Index 654-001

Rectangular Rapid Flashing Beacon Assembly

COMMENTARY

COMMENTS AND RESPONSES

LAST REVISION 11/01/21	REVISION	DESCRIPTION:	 FY 2022-23 STANDARD PLANS	RECTANGULAR RAPID FLASHING BEACON ASSEMBLY	INDEX 654-001	SHEET 2 of 2
---------------------------	----------	--------------	--	--	------------------	-----------------

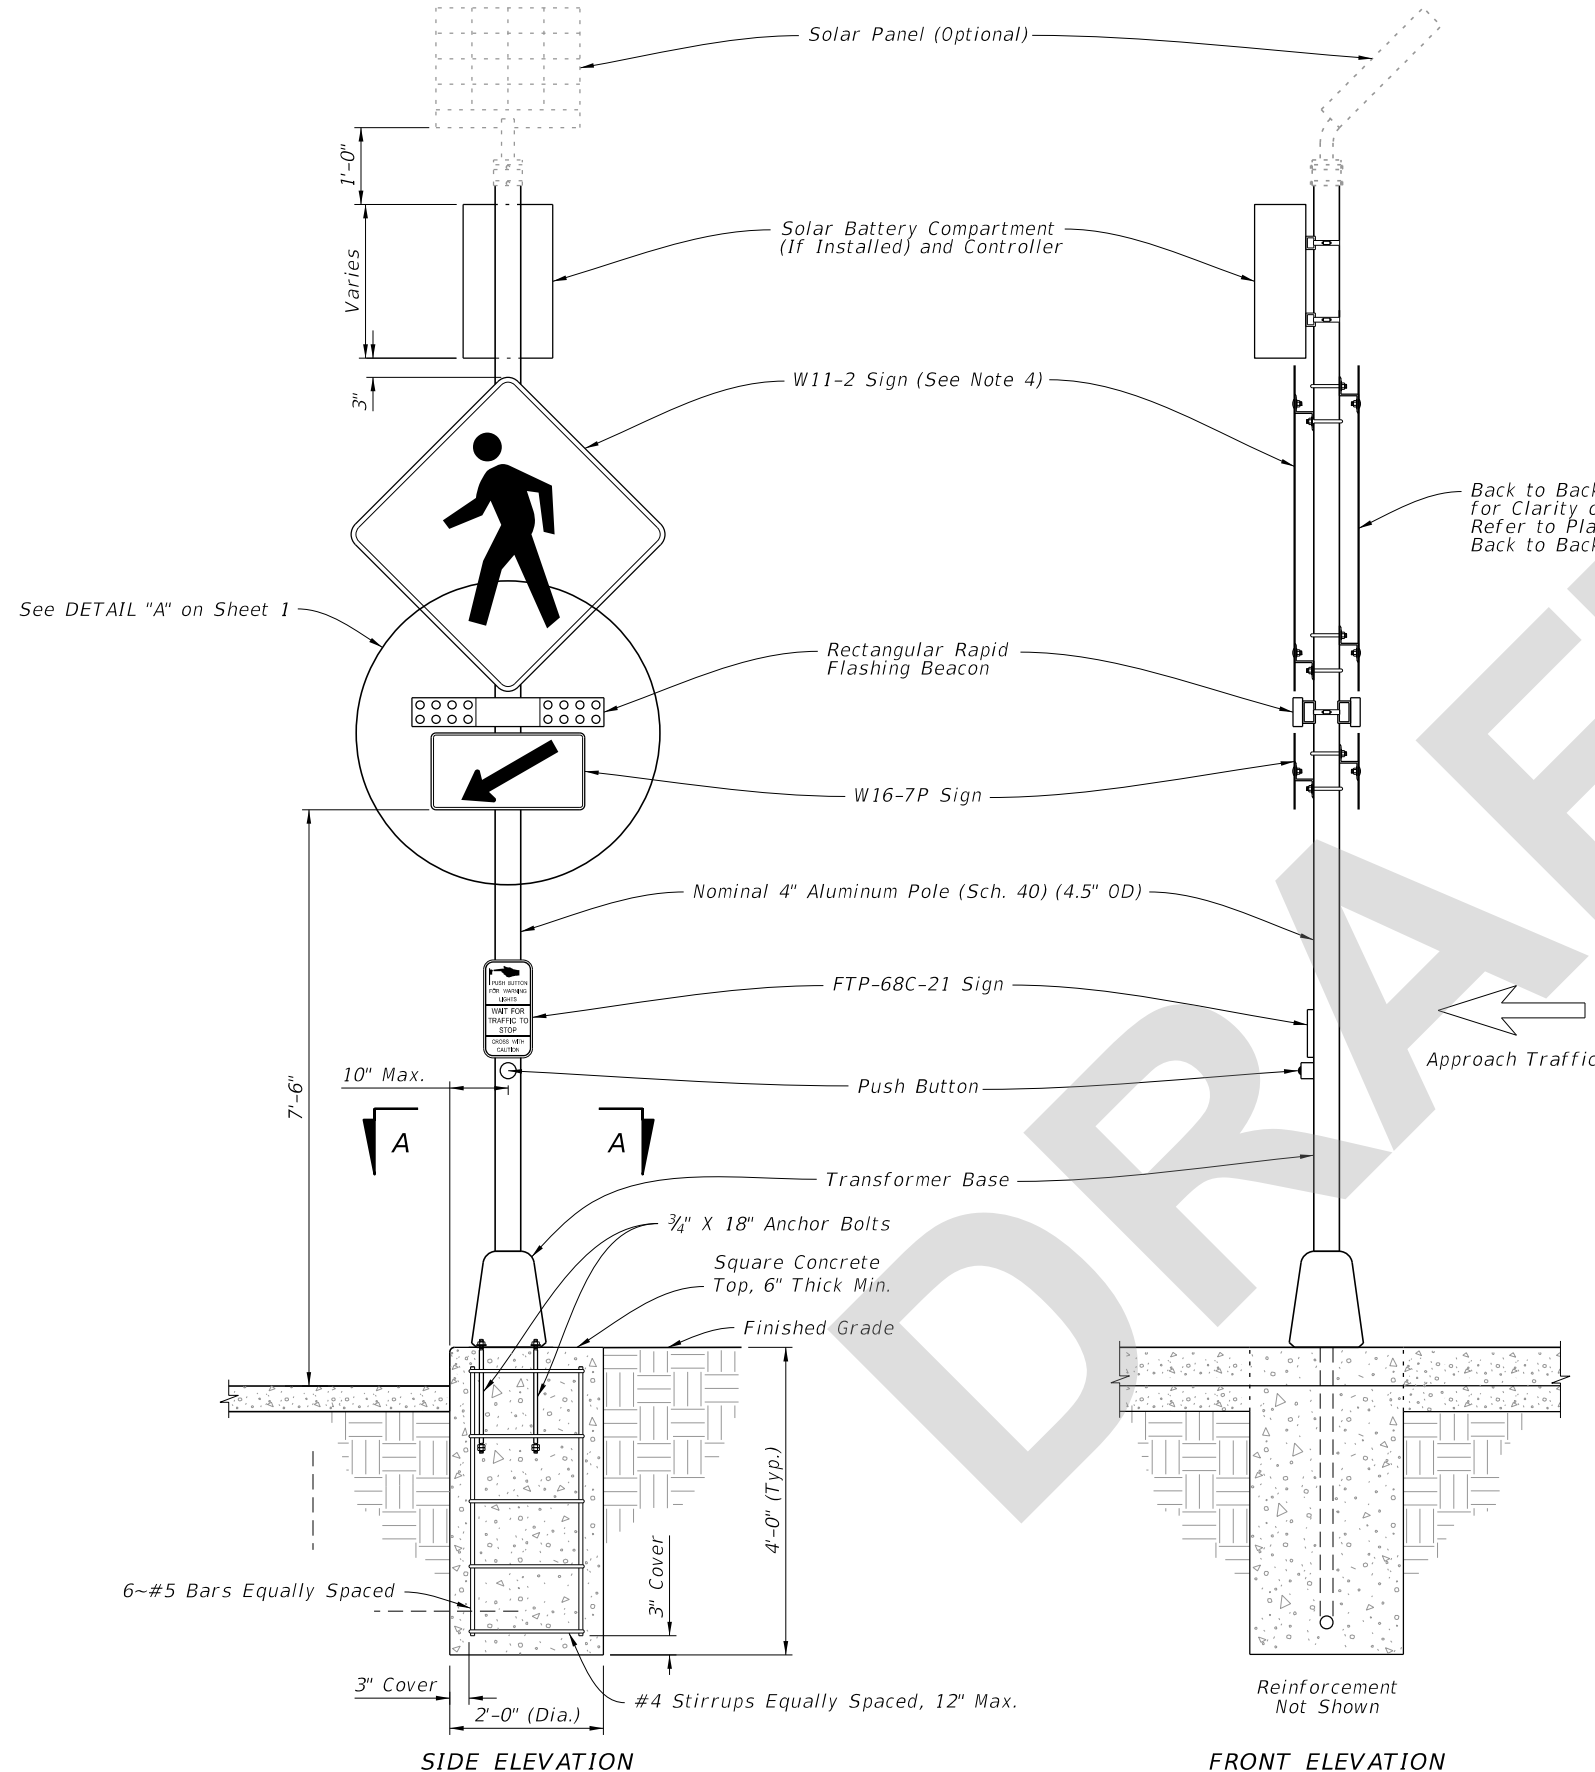
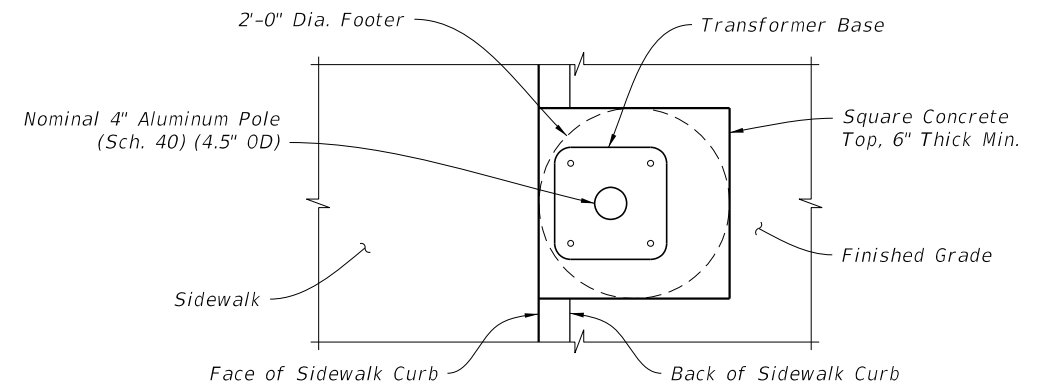
COMMENT: Has the revision of pole diameter callouts from 4" nominal to 4.5" OD been properly coordinated? This change could incur cost updates and other design considerations and affect APL. Were structural parameters considered? Specification 646 references 4" nominal which needs to be updated.

RESPONSE: The pole/posts are not changing with this update so there are no issues with the APL or additional costs incurred. This change was requested by the Structures Office to make callouts consistent with other Indexes that specify pole/post dimensions. The 4" nominal and 4.5" OD are the same callout in this scenario based on ASTM B429 which is a requirement of Spec 646. Although there is no conflict, Spec 646 will be updated to be consistent with the new callout in Indexes 646-001, 654-001, 695-001, and 700-120. The callout in the indexes will be updated to clarify that the poles/posts are not changing.

Change Made: **Revise callouts in the Indexes and Spec to read "Nominal 4" Aluminum Pole (Sch. 40) (4.5" OD)"**
